PERRY NUCLEAR POWER PLANT

Perry Nuclear Power Plant
Docket No. 50-440
Technical Specification
Change Request - ECCS Actions

This amendment requests revision of Technical Specification 3.3.3 Actions, to make the Actions for various ECCS Actuation Instrumentation consistent with the purpose and logic of the instruments involved.

Figure 1

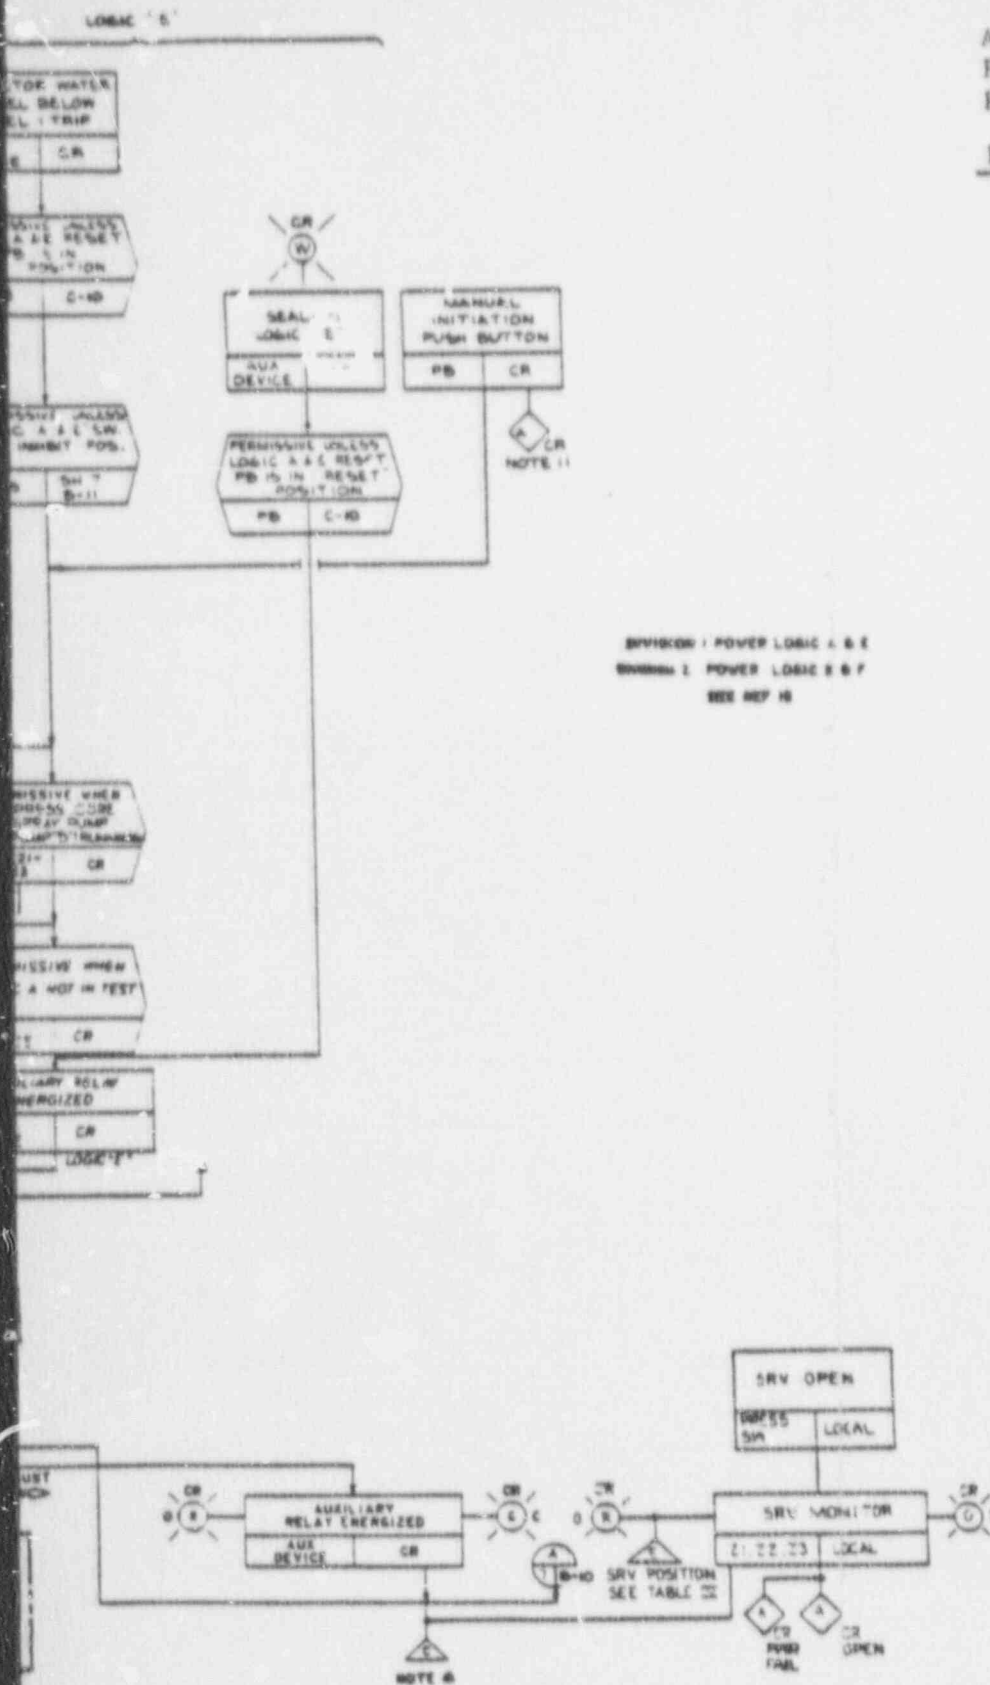
The ADS actuation system is discussed in the USAR Section 7.3.1.1.1.2 and the simplified logic for one trip system (Division 1) is depicted on USAR Figure 7.3.3, Sheet 6 of 7. Figure 1 of this letter is a reproduction of the applicable parts of the USAR Figure. In addition, Figure 2 provides another depiction of the Division 1 and 2 ADS Trip System logics, and shows that either logic train actuation will result in all eight ADS valves opening. As shown on this logic the Manual Initiation pushbuttons form a part of the overall initiation logic for both Division 1 and Division 2. For Division 1 [and 2] the ADS logic is initiated manually when the manual initiation pushbuttons in channels A and E [B and F] are depressed and there is a low pressure ECCS system running (LPCS or LPCI A for ADS Division 1, LPCI B or C

For example, as can be seen on Figure 1 and 2 of this letter, the Reactor Vessel Water Level-Low, Level 3 instruments are vital to the automatic actuation of the ADS trip system. However, the action required when one of these channels becomes inoperable is to declare the ADS trip system inoperable (ACTION 31). This is the appropriate action since the other Division can complete the automatic ADS logic if necessary. If the trip system is declared inoperable, ACTION c.1 of Technical Specification 3.3.3 permits 72 hours or seven days (depending on the operability of the HPCS and RCIC systems) to restore the trip system to OPERABLE status.
